CrownRidge Subdivision

City of San Antonio
Development Services Department
Master Development Plan
APPLICATION

Project Name: Babcock/Luskey Tract

MDP
City of San Antonio
Development Services Department
Master Development Plan
REQUEST FOR REVIEW

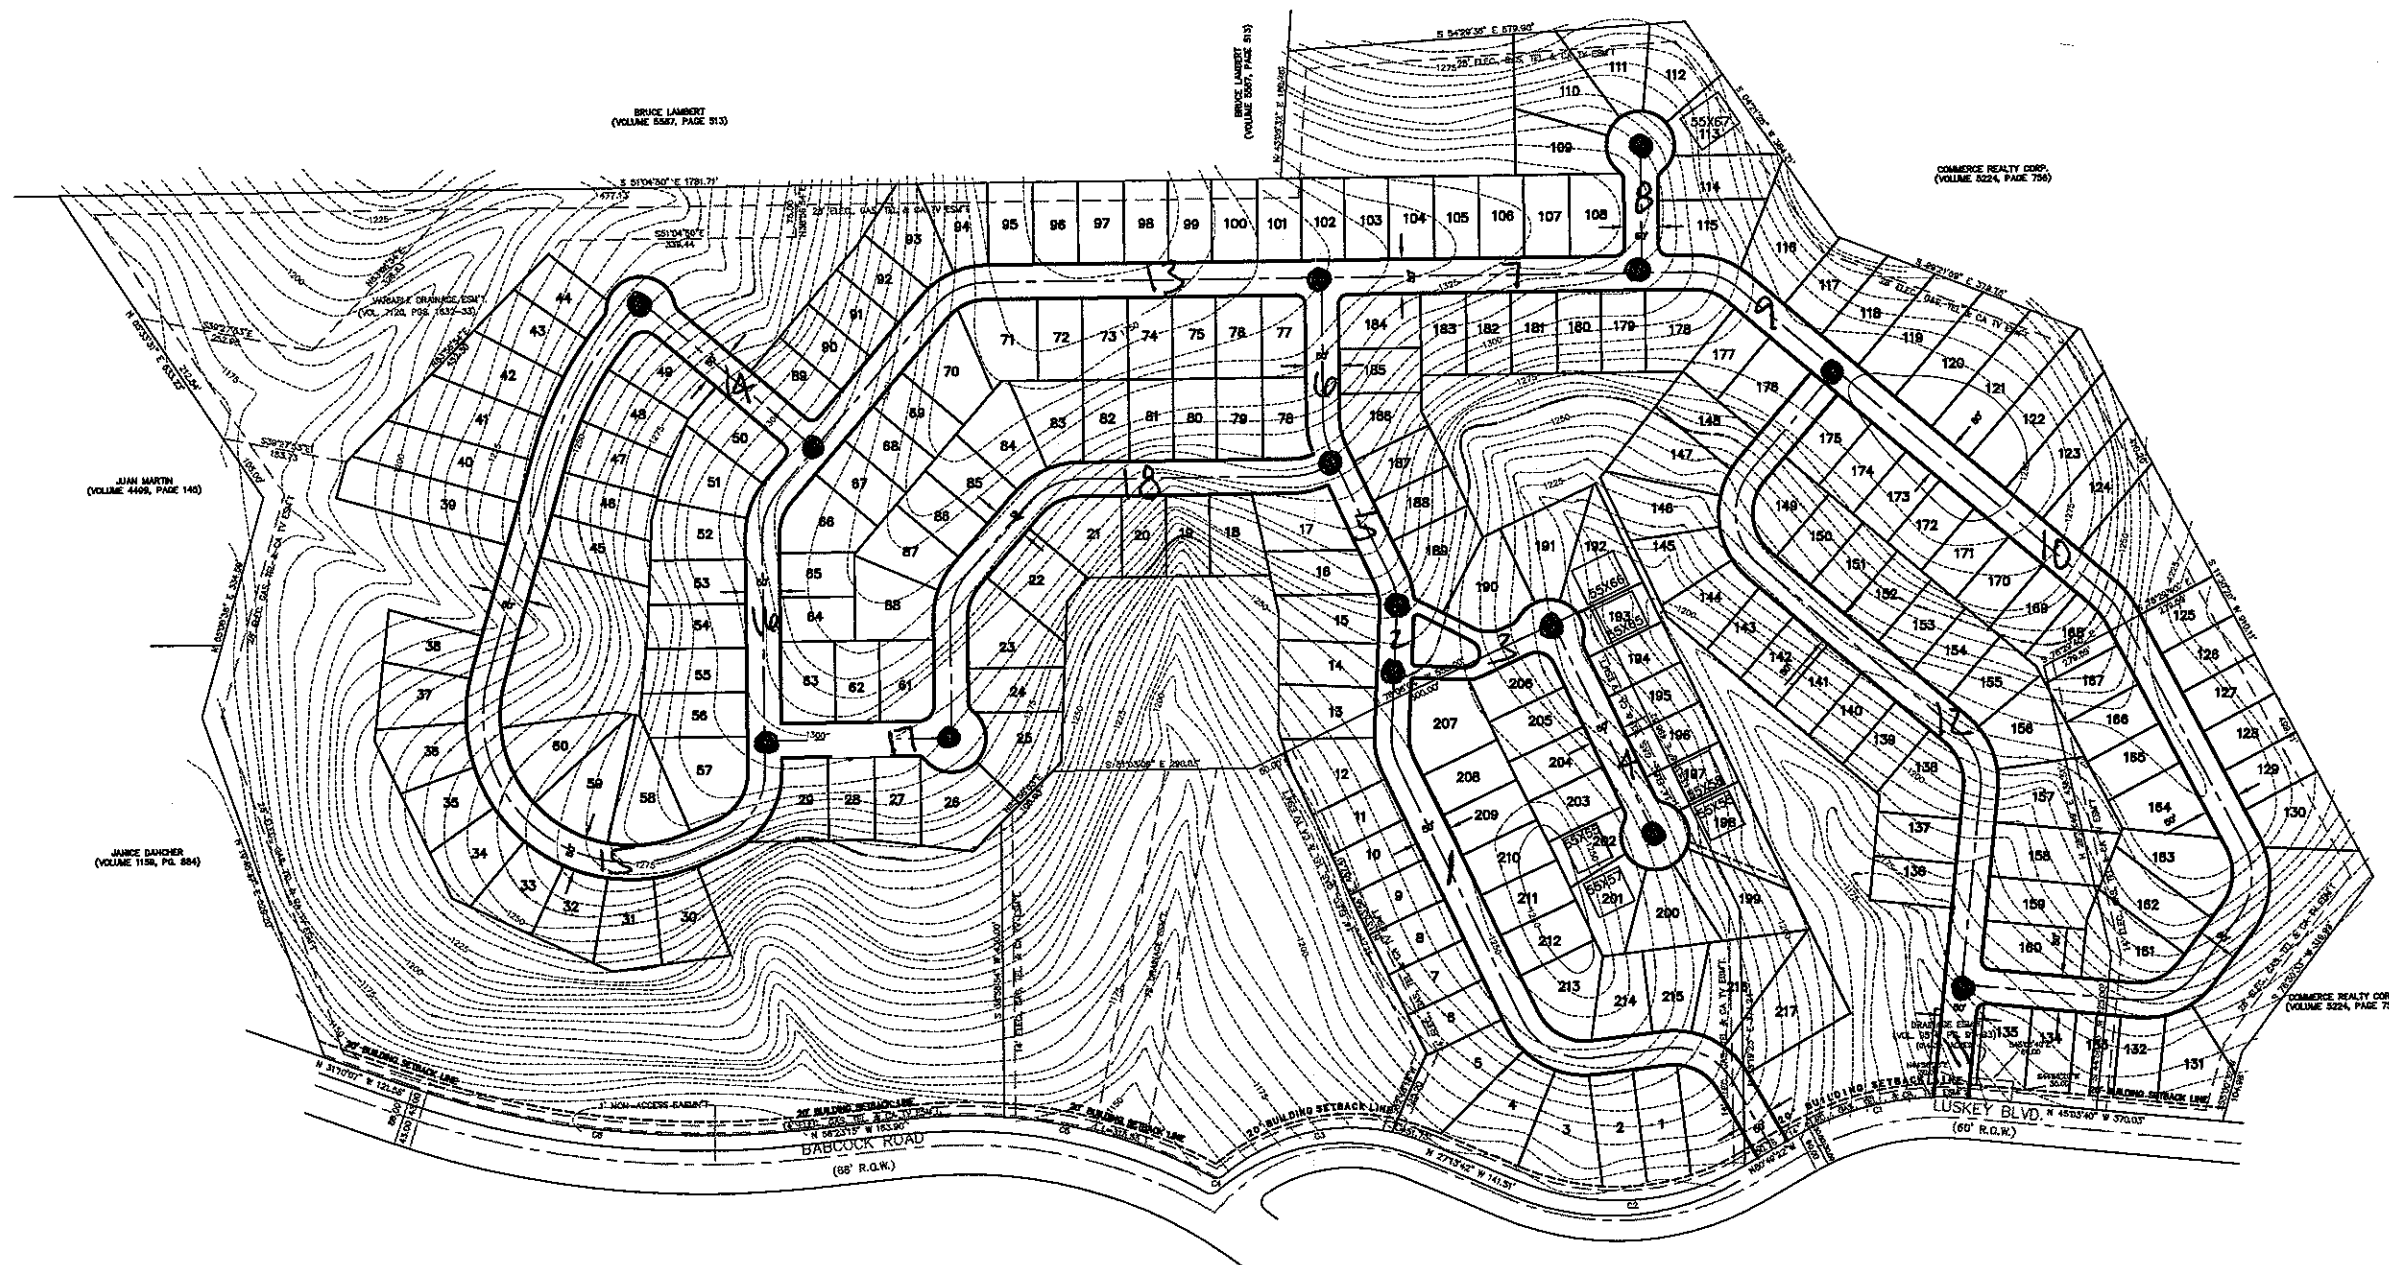
Comments: MAJOR THOROUGHFARE APPROVED 9/9/05
MASTER DEVELOPMENT: SHOW THE LOCATION OF ALL ENTRANCES ON TO
EXIST/PROPOSED ADJACENT RDWAYS. 35-B101(C) F(14)
2. REQUIRE (2) SETS OF COORDINATES 35-B101(C) F(2), 35-B101(C) F(1)
3. REQUIRE PROJECTION OF STREET, U-2 BETWEEN LOTS 94-101, AND
U-1, BETWEEN LOTS 116-130
4. SHOW ZONING ON PLANS.

1. Show the location of all entrances on to exist/proposed adjacent rdwys. 35-B101(c)F(14)
2. Require (2) sets of coordinates. 35-B101(c) E(2) and 35-B101(c) E(1)
3. Require projection of streets in Unit-1 between lots 116--130 and Unit-2 between lots 94-101.
4. Show the zoning.

Provide Master Development Plan showing existing and ultimate 100-year floodplain.

- Add a Local "B" Street cross section detail.
- Add Property Line Returns at all intersections (internal where missing and at the entrance streets).
- Grades are shown to be in excess of the 12 and 15% limits of UDC 35-506(d)(3). (23% and 31% grades and probable K-Value issues).

- Show the topographical lines extended onto Luskey Blvd.
